Rouse Hill Anglican College

*State Significant
Development
Modification Assessment
(SSD 8006 MOD 1)
February 2019*

Figure 5 | Proposed Plan No.MP-JS-10-04 (Source: SSD 8006 MOD 1)

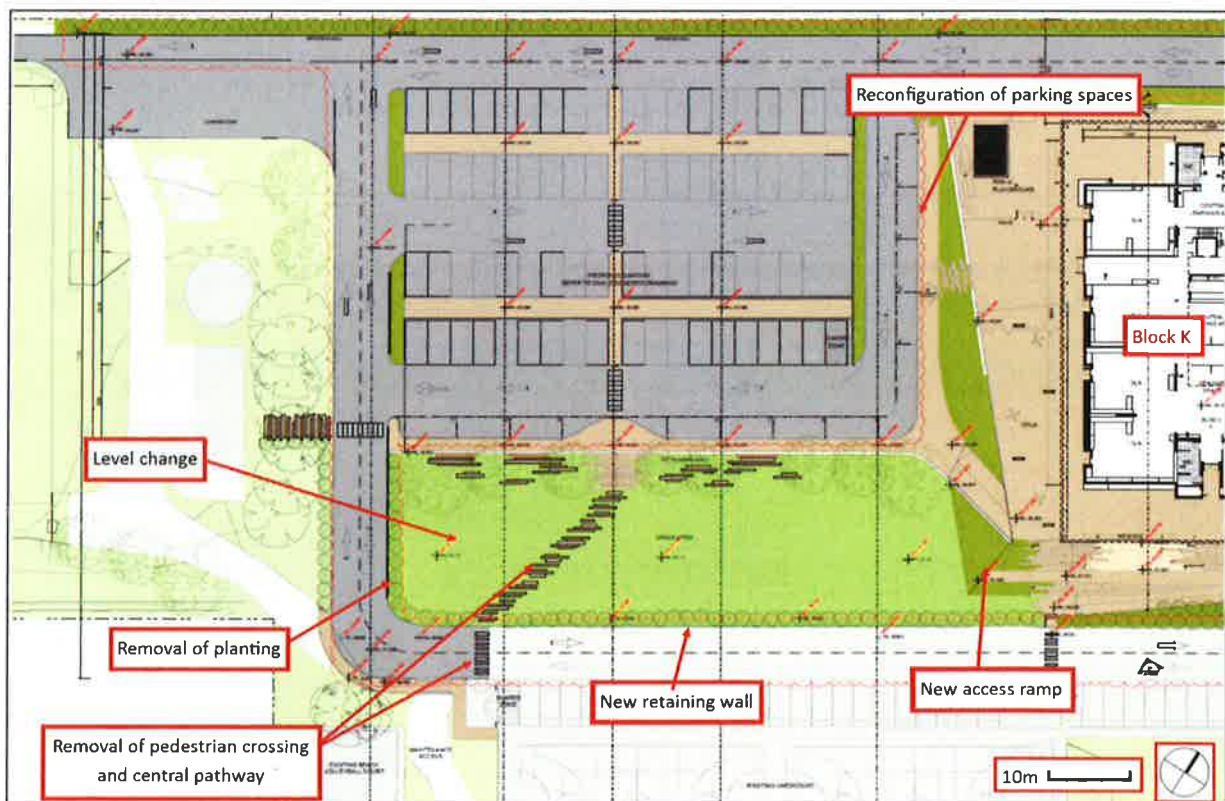
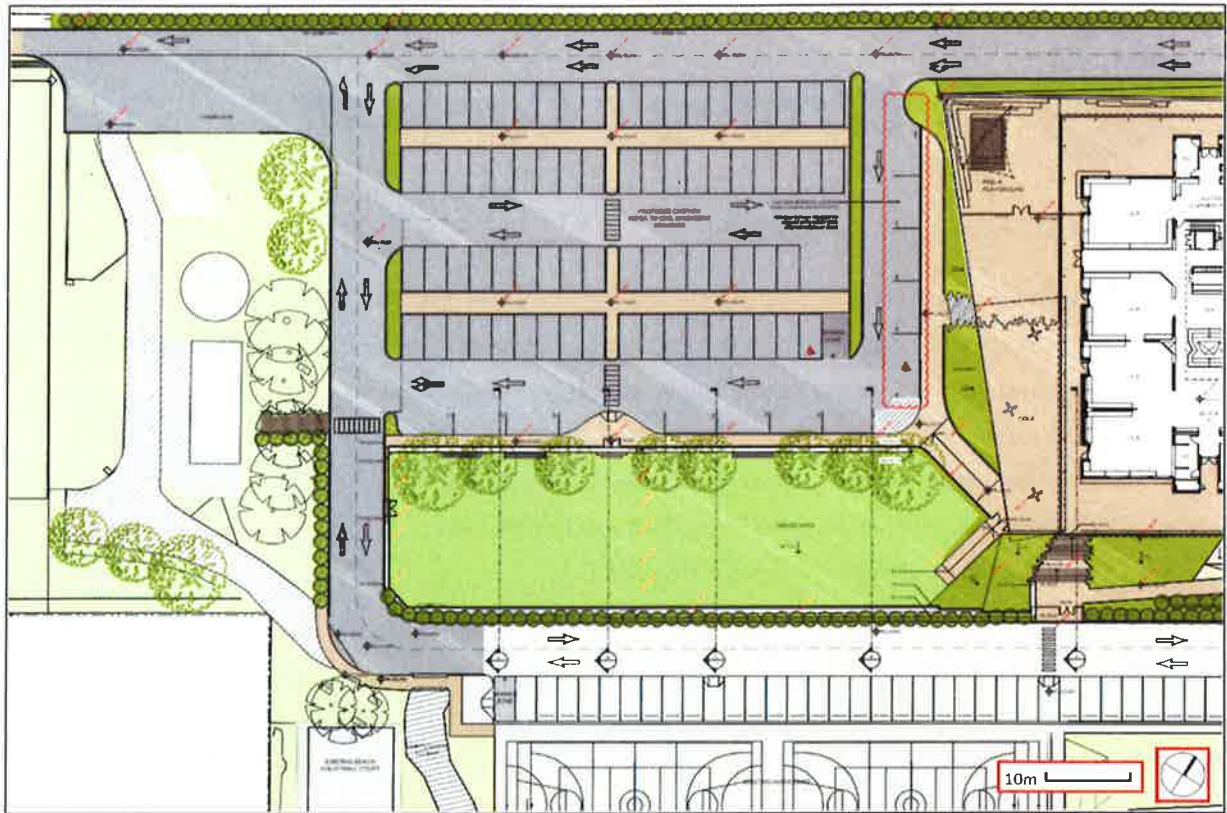
On 26 September 2018, the Applicant lodged an application (SSD 8006 MOD 1) seeking approval for (refer to **Figure 4** and **5**):

- minor change in levels of central grassed area.
- provision of retaining wall to southern and south-western edge of grassed area.
- provision of access ramp from Covered Outdoor Learning Area (COLA) adjacent to Block K to grassed area.
- minor modification to landscaping including removal of row a of proposed planting (mix of *Callistemon* sp. mature height of 2m) along south western edge of the grassed area.
- removal of central pathway through the grassed area and pedestrian crossing to the western end of the hardcourts.
- minor reconfiguration of 4 approved car parking spaces adjacent to Block K.

The modified landscape design includes the removal of approved planting along the south-western edge of the grassed area, provision of a retaining wall, access ramp for the COLA to the grassed area and removal of the central pathway through the grassed area.

The modification seeks approval to reconfigure four approved parking spaces adjacent to Block K. The modification also seeks removal of the internal approved pedestrian crossing to the western end and removal of the proposed connection from the carpark to the approved central pathway (now proposed to be deleted).

The Applicant is seeking approval for the removal of 10 (mix of *Callistemon* sp.) plants, which has resulted from the level change and introduction of a retaining wall. The proposed stepped sandstone retaining wall is a functional element separating the existing internal road from the grassed area. The height of the proposed retaining wall would range between approximately 1m to 2m. It is considered that the amendments serve a functional purpose and would not significantly change the overall landscape design.

The central pathway has been removed as the Applicant states it is no longer required as access to the grassed area would only be through safe entry points. The Department raises no objection to the removal of this pathway.

The Department notes the four car parking spaces have been relocated slightly south to provide a safe vehicular entry into the drop-off/pick-up zone. The total number of car parking spaces remains unchanged from the original approval. The pedestrian crossing has been removed due to the removal of the central pathway as pedestrian access is no longer required.

The Department considers the car parking amendments to be minor yet would improve the safety and efficiency of the drop-off/pick-up zone. The removal of the pedestrian crossing is not considered to result in any safety issues as an approved crossing closer to Block K would be retained, ensuring connectivity across the school site.

Figure 6 | Modified Carpark Section No.MP-JS-30-02 (Source: SSD 8006 MOD 1)

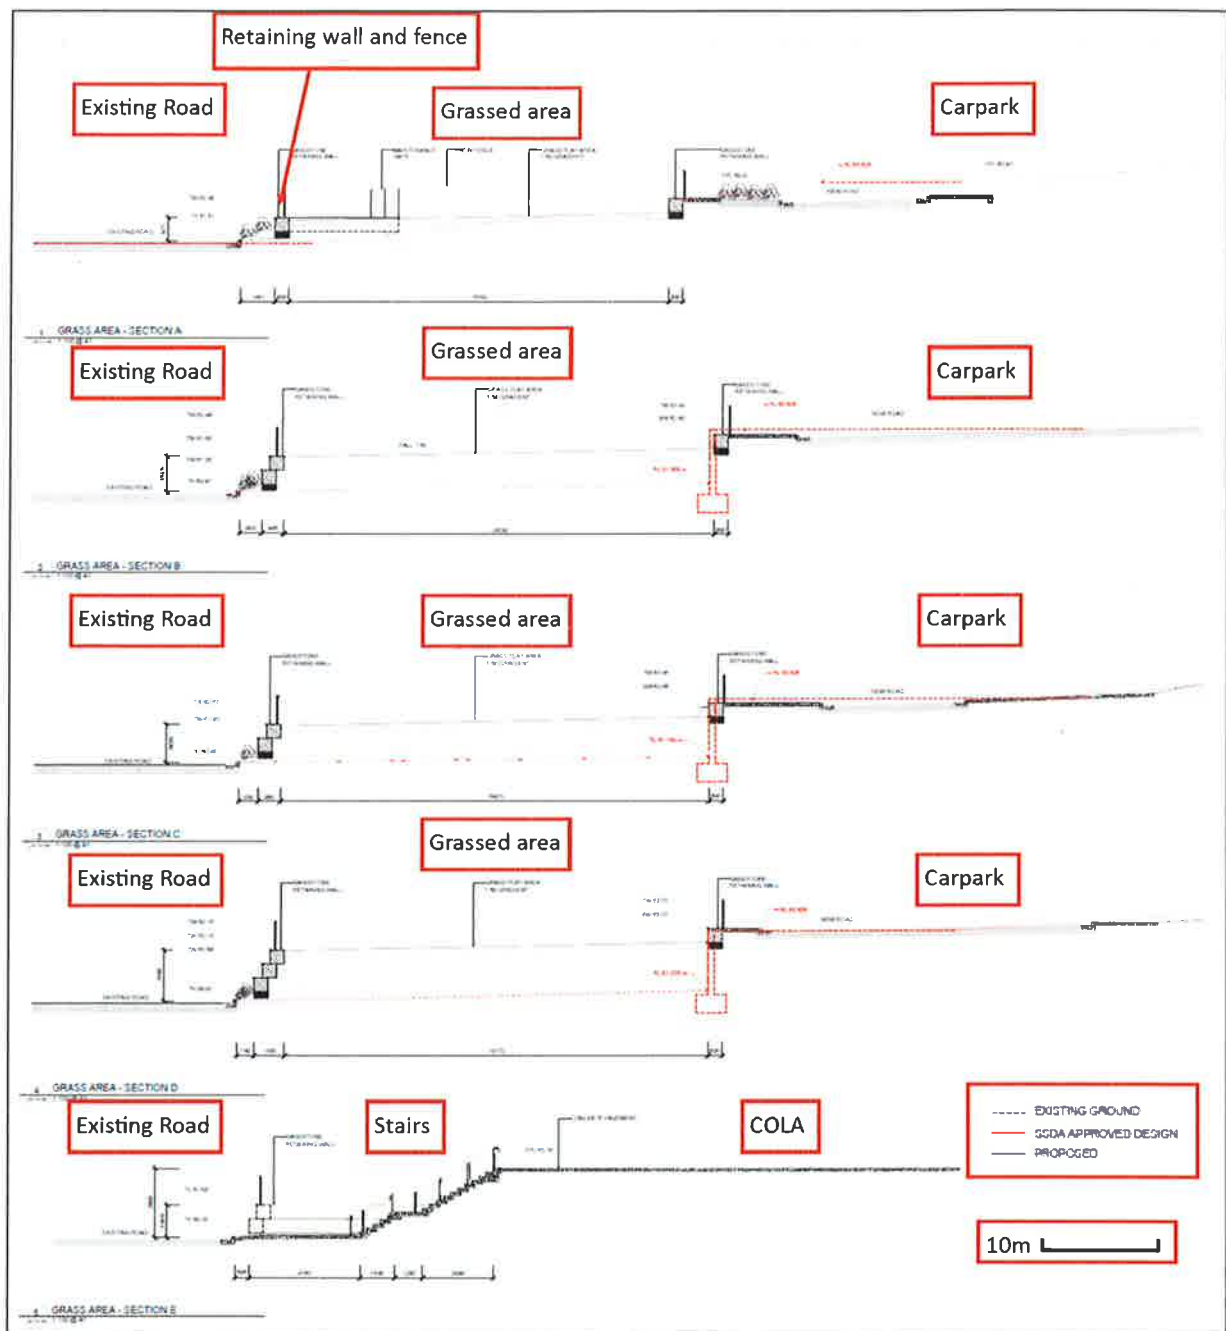
Site excavation for Phase 1 for the School has resulted in excess quantities of cut material which is currently being stockpiled on the site. The modification involves a minor change in level for the grassed area located behind Block K to the minimise offsite disposal of excavated material and to better manage the balance of cut and fill material on site. The approved levels of the grassed area compared to the proposed level ranges from a 1m to 2m increase.

The volume of cut approved in the original application (refer to **Figure 6**) provided a level that was consistent with the existing road to the south. The modification now provides a raised grassed area with retaining wall to separate the grassed area from the existing road.

The Department considers the proposed works are satisfactory as the environmental impact would be minimal due to reducing the extent of excavation and the volume of exposed soil on the site. There would also be reduced risks associated with stockpiling and exporting of soil as any dust, soil and water impacts would be minimised. The raised level is setback from the nearest road and the resultant level change would have minimal impact on visual amenity from the public domain.
